UNITED STATES PATENT AND TRADEMARK OFFICE

APPLICATION NO.	FIL	ING DATE	FIRST NAMED INVENTOR	ATTORNEY DOCKET NO.	CONFIRMATION NO
10/701,861	11	1/05/2003	Phillip Eugene Koloff JR.	9D-HR-25403	7798
7590 10/25/2006			EXAMINER		
John S. Beulick				AYRES, TIMOTHY MICHAEL	
Armstrong Teasdale LLP Suite 2600			ART UNIT	PAPER NUMBER	
One Metropolitan Square				3637	
St. Louis, MO	63102			DATE MAILED: 10/25/2006	6

Application No.	Applicant(s)					
	10/701,861	KOLOFF ET AL.					
Office Action Summary	Examiner	Art Unit					
•	Timothy M. Ayres	3637					
The MAILING DATE of this communication appears on the cover sheet with the correspondence address Period for Reply							
A SHORTENED STATUTORY PERIOD FOR REPLY WHICHEVER IS LONGER, FROM THE MAILING DA - Extensions of time may be available under the provisions of 37 CFR 1.13 after SIX (6) MONTHS from the mailing date of this communication. - If NO period for reply is specified above, the maximum statutory period v - Failure to reply within the set or extended period for reply will, by statute, Any reply received by the Office later than three months after the mailing earned patent term adjustment. See 37 CFR 1.704(b).	ATE OF THIS COMMUNICATION

Carroll '668 Figure 3

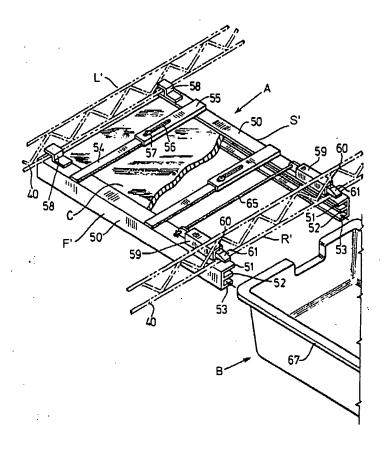
Claims 11, 16 and 21-23 are rejected under 35 U.S.C. 102(b) as being 1. anticipated by U.S. Patent 4,241,668 to Carroll. Carroll '668 discloses a drawer assembly with a pan support (A) made up of a wire member (40) having a first side (R') and a second side (L'). A first bracket (F') coupled to the first side (R') so that is removable without tools by pulling on a rod (65) to release latches (61). The wire member is not continuous as seen in figure 2, but is formed from continuous wire that is cut and welded to other wire members. A second bracket (S') coupled to the second side (L') so that the second bracket (S') is removable without tools also when the rod (65) is pulled. The second (S') bracket is substantially identical to the first bracket (F'). The first bracket (F') is coupled to the first side (R') by the latch member (61) and the second bracket (S') is coupled to the second side (L') by a hook member (58) The term refrigerator is nomenclature which is given no patentable weight. The first bracket (F') is a mirror image of the second bracket (S') and is therefore is in a reverse or inverse orientation from each other. Method is inherently provided for since all structural limitations are met.

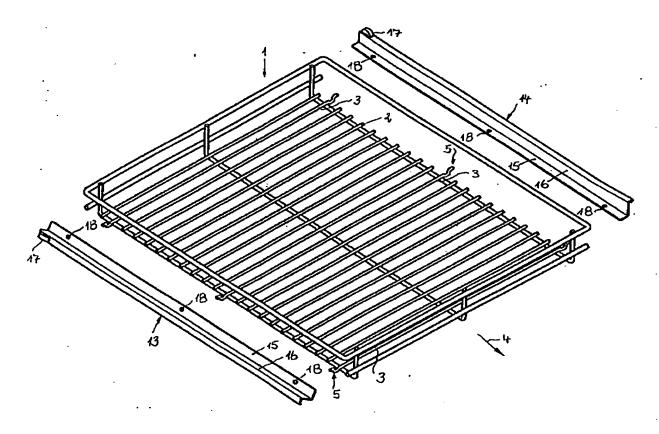
- 4. Claims 17, 19, and 20 are rejected under 35 U.S.C. 102(b) as being anticipated by US Patent Publication 2002/0084734 to Shih. Shih teaches a bracket (1) with a sidewall and a first rail (11) extending form the sidewall. A second rail (15) extends from the bottom of the side wall. The first rail (11) has slots (12) and an inwardly turned lip portion as seen in figure 3b. The second rail (15) has an inwardly turned lip portion (13). Slots in the second rail (15) are considered to be the spaces between each lip portion (13). "Sized to receive" is taken to mean that a slot has to be capable of receiving a U-shaped member and Kurtz's slot is capable of receiving a U-shaped member of some size. A slot is also considered to be an aperture and is also capable of receiving a hook of some kind. The pan support wire is not positive recited in the claims and therefore

has no weight other than the slots and apertures being capable of receiving the hooks and u-shaped member.
